MIDLAND UNITS 1 & 2  
JOB NO. 7220

REVIEW OF U.S. TESTING  
FIELD AND LABORATORY CONSTRUCTION  
TEST DATA ON SOILS USED AS FILL

BECHTEL ASSOCIATES PROFESSIONAL CORPORATION  
July 1979

FIGURE 1

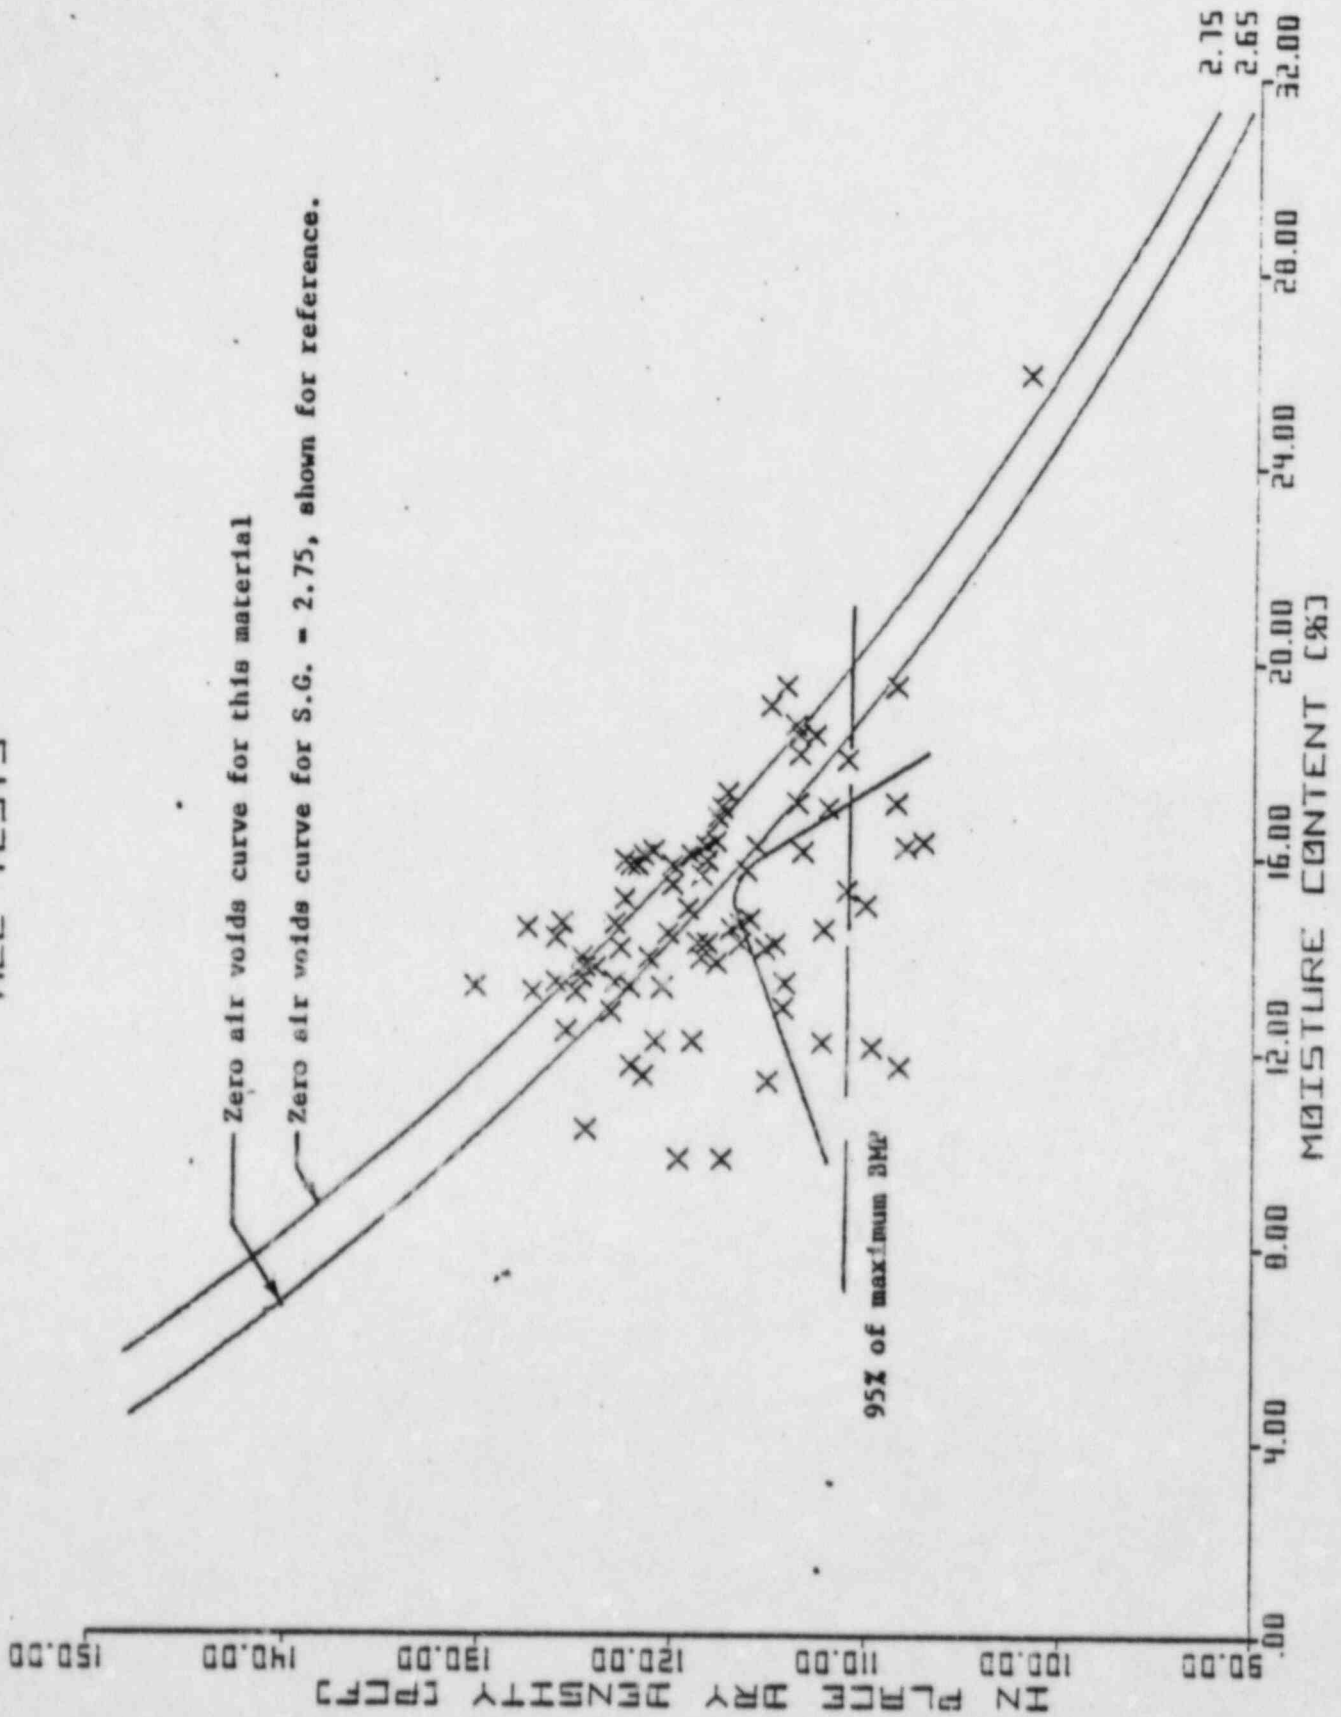
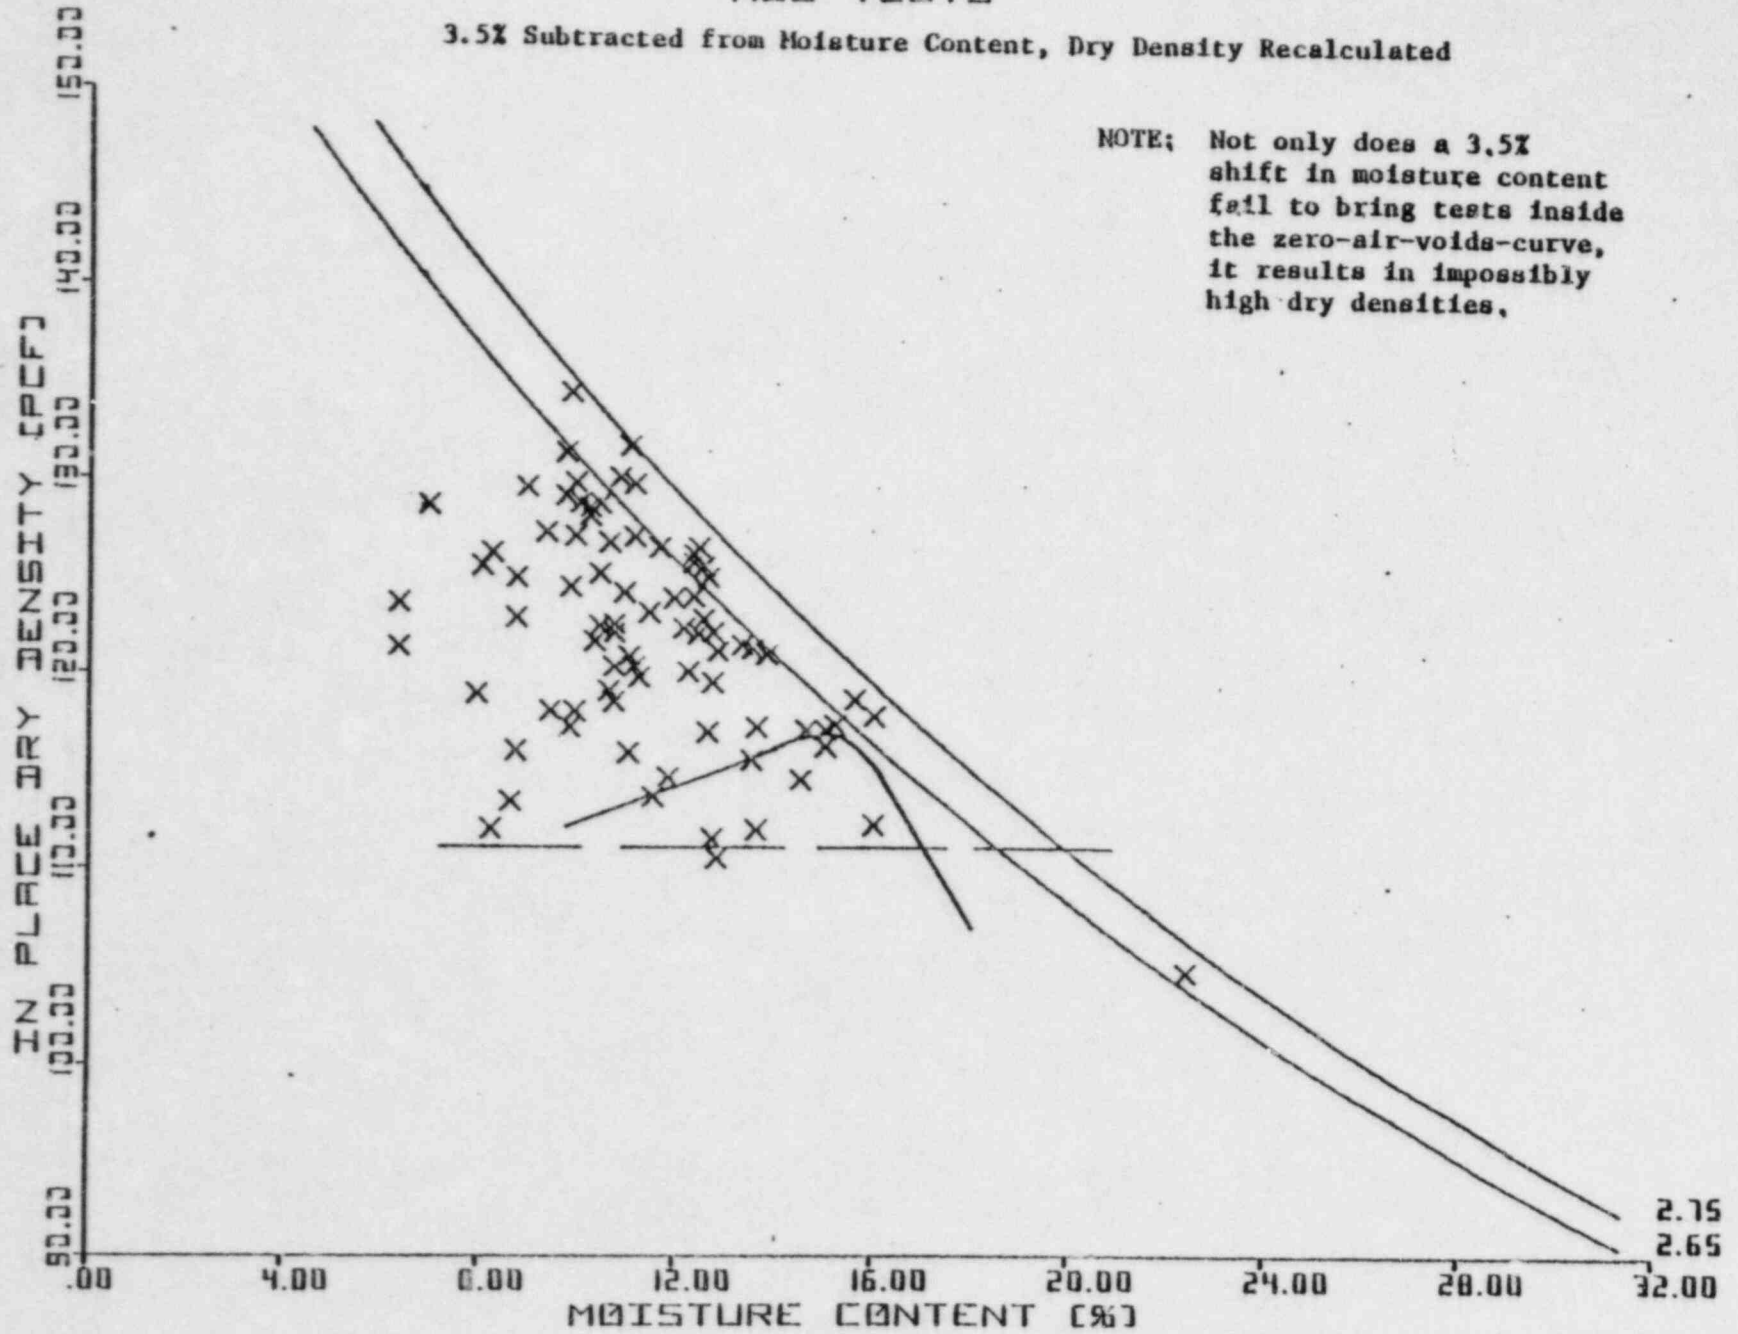
*Fig 1. shows many tests outside the 275 curve while figure 9 shows none - therefore this conclusion is not supported by these two figures. (The real accuracy of the instrument should be determined.)*
